MILITARY SPECIFICATION

SEMICONDUCTOR DEVICE, SILICON,
VOLTAGE REFERENCE (TEMPERATURE-STABLE)
TYPE 1N430A, 1N430B

This amendment forms a part of Military Specification MIL-S-19500/335(EL) 1/, 28 June 1965, and is approved by the US Army Electronics Research and Development Command, Department of the Army, and is available for use by all Departments and Agencies of the Department of Defense.

FIGURE 1. Physical dimensions.

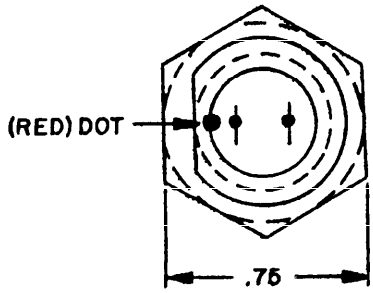
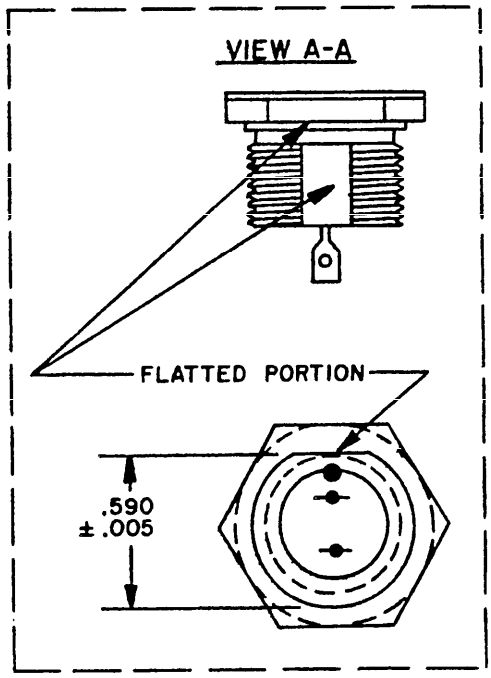
Figure 1, delete and substitute new figure 1 as printed on page 2 of this amendment.

NOTES:
1. Dimensions are in inches.
2. Unless otherwise specified, tolerances are ±.005 (0.13 mm) on three place decimals and ±.02 (0.5 mm) on two place decimals.
